# Access Compliance Report

## Public Rights-of-Way

Intersection ID: 16373	Main Street: MONROE RD	Cross Street: EATON RD	Location: NW
ADA ID: 32F154071E40	Ramp Type: PerpDiag	Initial Pass/Fail: Fail	Overall Compliance: No
		Severity Score: 25

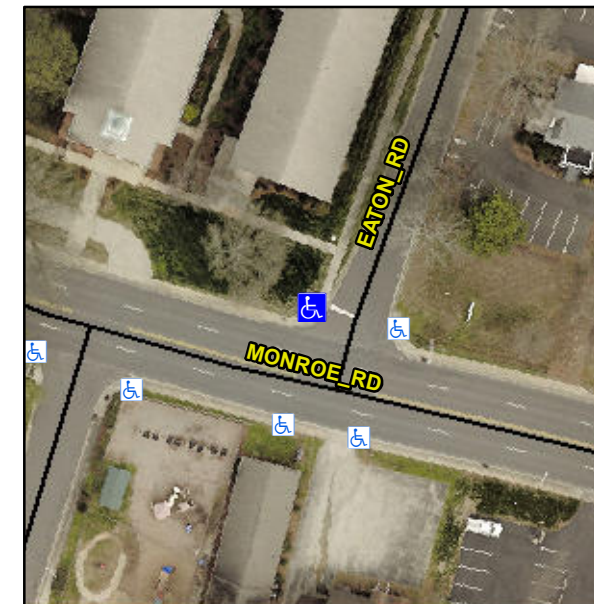
**R304.2.2, R304.5.3**

Compliance	Description	Data	Compliance	Description	Data
N/A	Ramp Length (in)	55.0	No	Ramp Slope (%)	8.8
Yes	Ramp Width (in)	48.0	No	Ramp XSlope (%)	6.1
N/A	Flare Type LT	N/A	N/A	Flare Type RT	N/A
N/A	Flare Slope LT (%)	N/A	N/A	Flare Slope RT (%)	N/A
N/A	Flare Traversable LT?	N/A	N/A	Flare Traversable RT?	N/A
N/A	Landing Length (in)	N/A	N/A	DWS Provided?	N/A
N/A	Landing Width (in)	N/A	N/A	DWS Contrast?	N/A
N/A	Landing Slope (%)	N/A	N/A	DWS Length (in)	N/A
N/A	Landing X Slope (%)	N/A	N/A	DWS Full Width?	N/A
N/A	Landing Curb? (Y/N)	N/A	N/A	DWS Offset (in)	N/A
N/A	Shared Landing?	N/A			
N/A	Gutter Ponding?	N/A	N/A	Gutter Slope (%)	N/A
N/A	Gutter Lip Ht (in)	N/A	N/A	Gutter X Slope (%)	N/A
N/A	Painted X Walk1?	No	N/A	Painted X Walk2?	No
	X Walk 1 Direction	To SW		X Walk 2 Direction	To SE
N/A	X Walk 1 Width (in)	N/A	N/A	X Walk 2 Width (in)	N/A
	X Walk 1 Slope (%)	6.7		X Walk 2 Slope (%)	1.6
	X Walk 1 X Slope (%)	1.9		X Walk 2 X Slope (%)	5.5

**Remove & Replace Curb Ramp With Two New Directional Ramps or Equivalent.**
